Office Action Summary

10/530,949

SHIMIZU, MAKOTO

DETAILED ACTION

FIG. 4

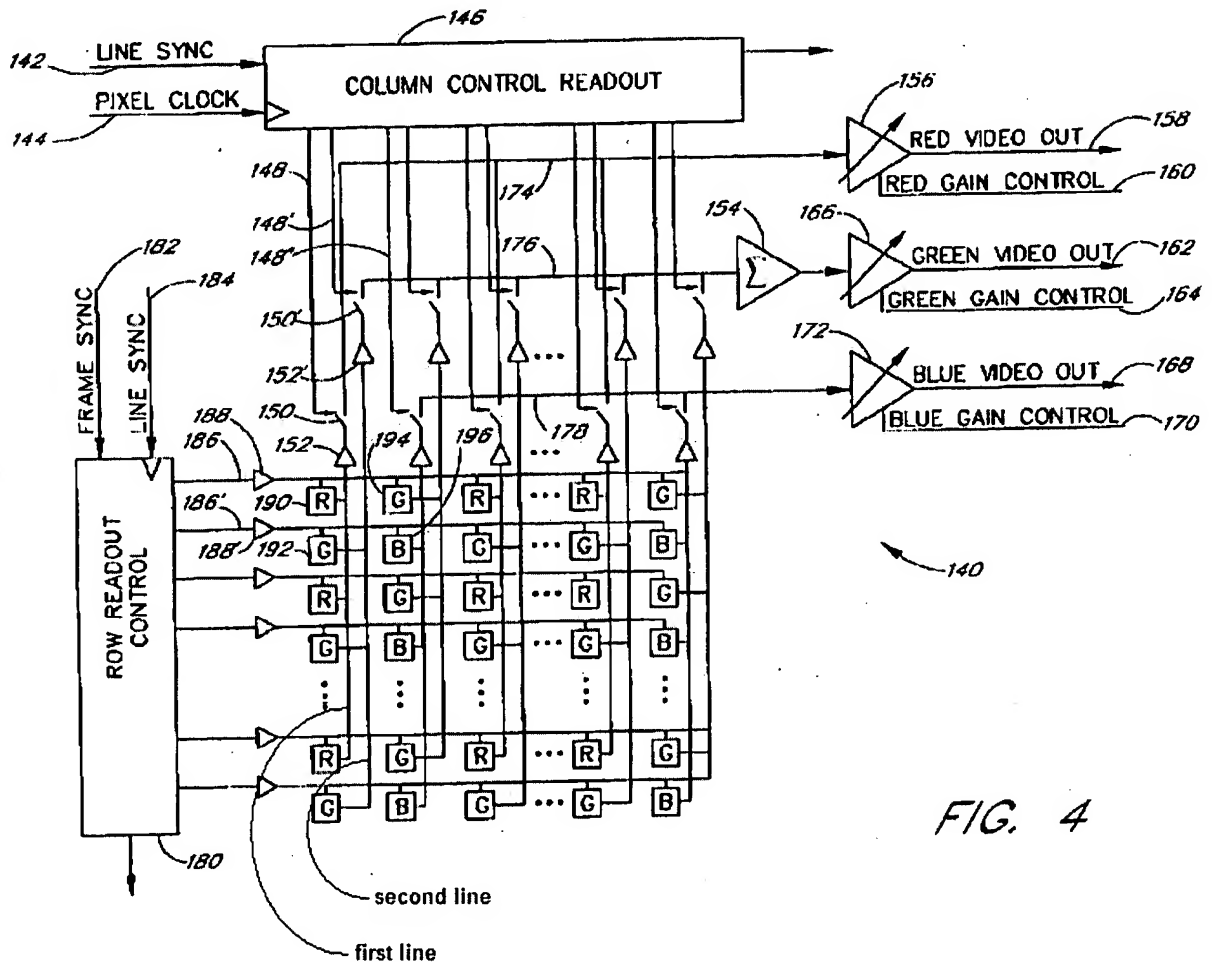
Regarding claim 1, Neter discloses an area image sensor (Fig. 4) comprising a plurality of image pick-up elements (190, 192, 194, 196 as shown in fig.4) arranged in a matrix including a plurality of element rows and a plurality of element columns (See fig. 4); a plurality of signal lines (see plurality of lines in fig. 4 as illustrated below) allocated to a respective one of the element columns (each column has two signal lines); and wherein each of the image pick-up elements belonging to said one of the element columns is connected to only one of the signal lines (each of the elements are connected to only one of the signal lines as shown in fig. 4), and wherein each of the signal lines is connected to at least one of the image pick-up elements belonging to said

one of the element columns (note that each of the signal lines is connected to at least one of the image pick-up elements belonging to said one of the element columns as shown in fig. 4) (Col. 9, line 34 – col. 10, line 14).

Neter does not explicitly disclose a plurality of A/D converters connected to the signal lines, respectively.

Regarding claim 2, the combined teaching of Neter in view of Sugiki as discussed and analyzed in claim 1 teaches that each of the image pick-up elements comprises a photoelectric conversion element, and a switching element (See Sugiki, elements 402 and 404 as shown in fig. 10) connected to the photoelectric conversion element. Grounds for rejecting claim 1 apply here.

signal lines (See Neter, red element 190 is connected to a first signal line in the column and green element is connected to a second signal line in the column as shown in fig. 4).

Regarding claim 4, the combined teaching of Neter in view of Sugiki as discussed and analyzed in claim 1 teaches a plurality of address lines (see Neter, address lines 186 as shown in fig. 4) and an address line selection circuit (Fig. 4: 180) connected to the address lines, wherein each of the address lines is connected to the image pick-up elements of a respective one of the element rows, and wherein the address line selection circuit selects plural ones of the address lines simultaneously (Neter, col. 9, line 34 – col. 10, line 14).

FIG. 4

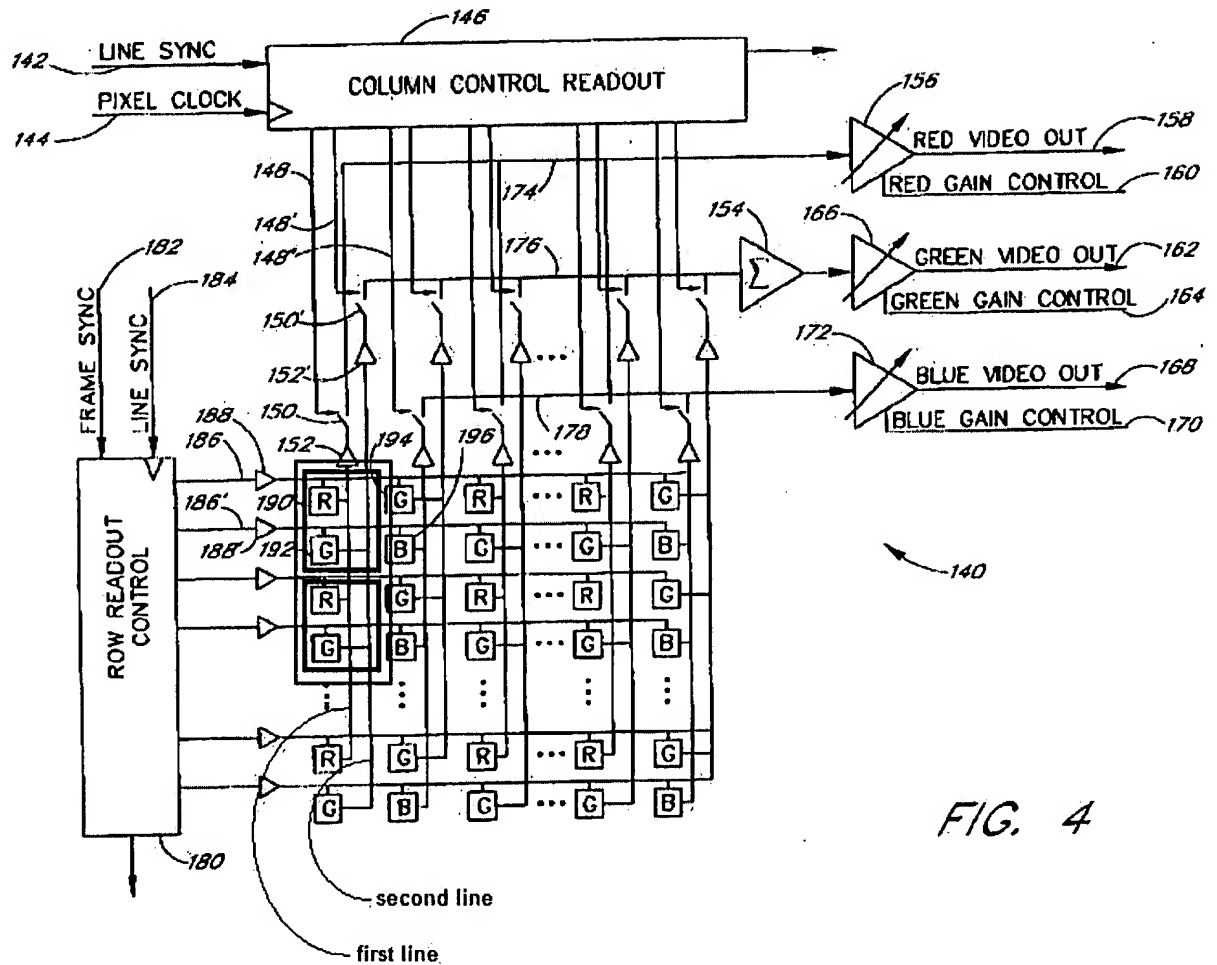
Regarding claim 6, Neter discloses an area image sensor (Fig. 4A) including a plurality of image pick-up elements (190, 192, 194, 196 as shown in fig.4) arranged in a plurality of columns and a plurality of rows (See fig. 4), the area image sensor comprising: a plurality of signal lines (see plurality of lines in fig. 4 as identified above) allocated to a respective one or two of the columns of the image pick-up elements (Fig. 4); and wherein small groups (see small groups as defined with a square surrounding a red and a green image pick-up elements in fig. 4 below) each consisting of successive image pick-up elements are defined in each of the columns of the image pick-up elements, the number of the image pick-up elements included in each of the small

groups corresponding to the number of the signal lines allocated to the column (the number of image pick-up elements in the group corresponds to the number of lines in the column (two image pick-up elements for two lines); see fig. 4 as illustrated below by the Examiner), the image pick-up elements included in each of the small groups being connected to different signal lines from each other (red element 190 is connected to a first signal line in the column and green element is connected to a second signal line in the column as shown in fig. 4); wherein large groups (see large group as defined using large squares surrounding two smaller groups as illustrated in fig. 4 below; although only one large group is illustrated, since the sensor area is larger than shown in the figure, multiple large groups are inherently present) each consisting of at least two successive small groups are defined in each of the columns of the image pick-up elements, and wherein, in each of the large groups, there are at least two connection patterns of the image pick-up elements to the signal lines on a small group basis (i.e. in the image sensor area, for the first columns it would show a pattern wherein the red image pick-up elements are connected to the first signal line and the green image pick-up elements are connected to the second signal line in that column as shown in fig. 4) (Col. 9, line 34 – col. 10, line 14).

Neter does not explicitly disclose A/D converters connected to the signal lines, respectively.

Regarding claim 7, the combined teaching of Neter in view of Sugiki as discussed and analyzed in claim 6 teaches that in each of the columns of the image pick-up elements, the number of the small groups included in each of the large groups is powers of 2 (In Neter, note that the large group as illustrated by the Examiner as shown in fig. 4 above include two small groups). Grounds for rejecting claim 7 6 apply here.

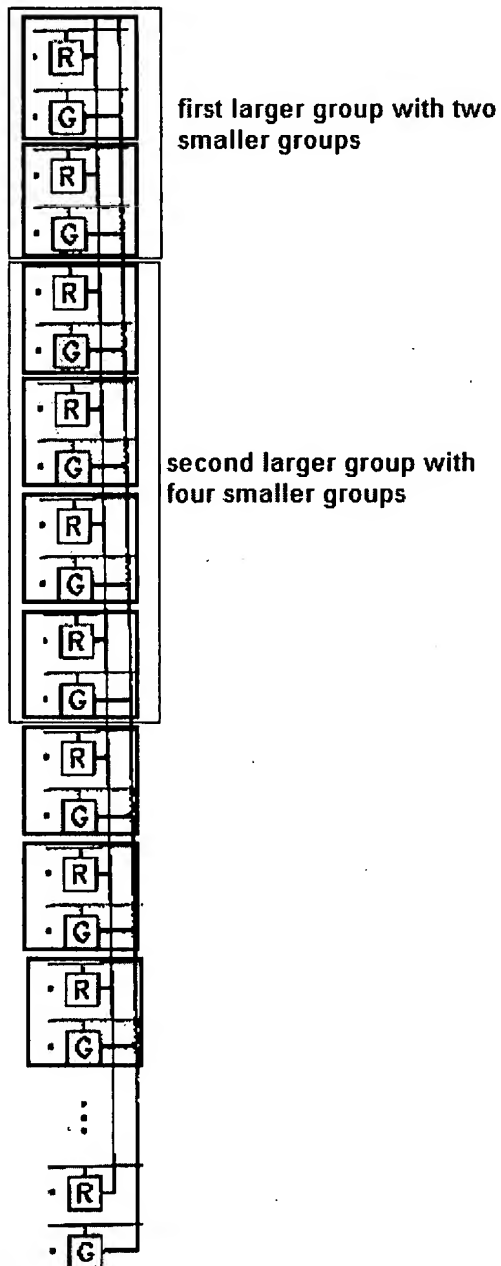
Regarding claim 8, the combined teaching of Neter in view of Sugiki as discussed and analyzed in claim 6 teaches that two or more kinds of large groups differing from each other in number of the small groups included therein are defined in each of the columns of the image pick-up elements (as illustrated below if the image sensor is expanded to show more image pick-up element, it would teach the capacity of

having two or more kinds of large groups differing from each other in number of the small groups included therein defined in each of the columns of the image pick-up elements. A portion of the expanded image sensor in Neter, Fig. 4 is illustrated below).
